FORD AXOD INTERMEDIATE CLUTCH PACK CHANGE

CHANGE: Beginning in model year 1988, a "Wave Plate" was added to the intermediate clutch pack on 3.8L models, and a flat "Spacer Plate" was added on 3.0L models.

FIGURE 1

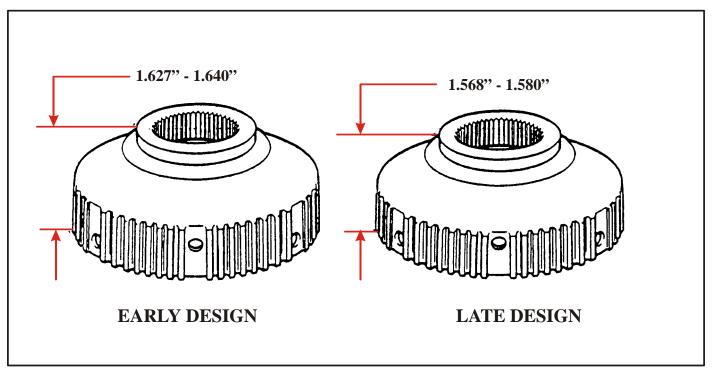
- (2) INTERMEDIATE CLUTCH HUB Overall height was made shorter by approximately .060" with no identifying marks. The hub MUST be measured with a dial caliper or depth gage. The 1st design hub will measure 1.627"-1.640", and the 2nd design hub will measure 1.568"-1.580" as shown in Figure 1.

FIGURE 2 FIGURE 3

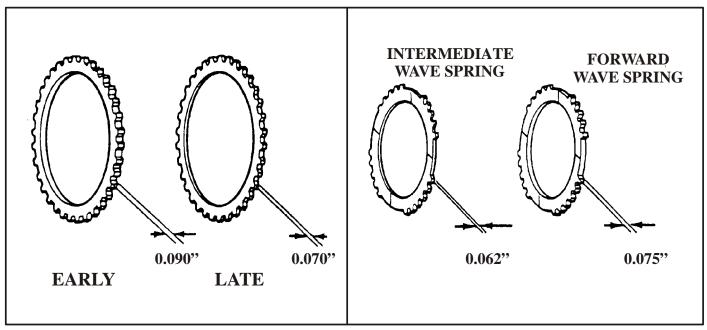
- (3) INTERMEDIATE CLUTCH STEEL PLATES Thickness was reduced by .020" to help accommodate the added wave plate on 3.8L models, or the added spacer plate in 3.0L models. The 1st design steel plates are .090" thick, and the 2nd design steel plates are .070" thick as shown in Figure 2.

FIGURE 4

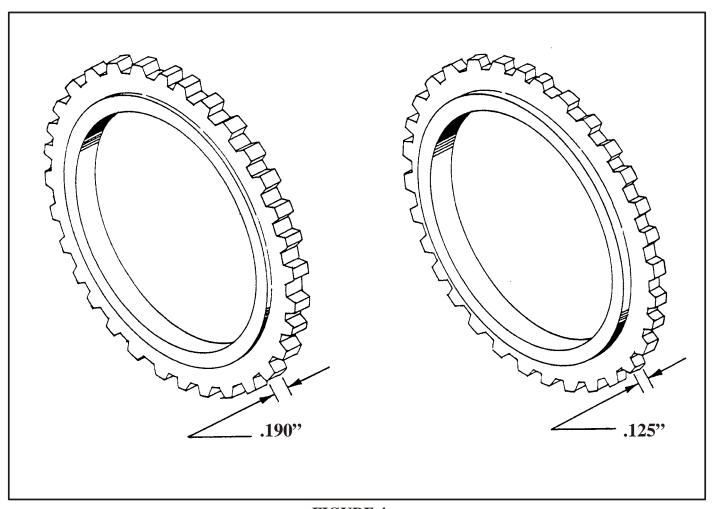
- (4) INTERMEDIATE CLUTCH PRESSURE PLATE Thickness was reduced by .065" to help accommodate the added wave plate on 3.8L models, or the added spacer plate on 3.0L models. The 1st design pressure plate is .190" thick, and the 2nd design pressure plate is .125" thick as shown in Figure 4.
